Service Information

TITLE : Sprso water inlet change

MODEL : All Sprso models

DATE : 2022-01-25 **NUMBER :** SI 220125

6.000.431.029 water inlet and housing set Sprso

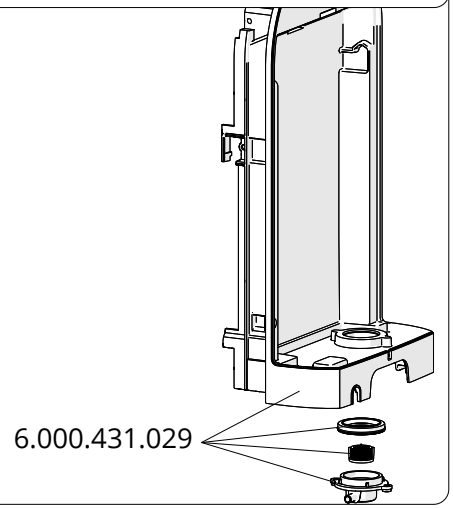
Because of a change in the water inlet of the Sprso this part doesn't fit older Sprso machines.

Cause:
With the old water inlet it was possible to place the water tank incorrect on the machine which could cause a leakage between the water inlet and water tank.

Solution:
For this reason the dimensions of the water inlet and the housing of the Sprso are changed.
The old and new part can not be exchanged with each other as the fit would not be good.
We have created a set of parts that fit older Sprso machines in case these should ever be changed.

For machines with a lower serial number as of **020002238255** the set must be used.

The set contains:
- water inlet
- sealing ring
- sieve
- back panel
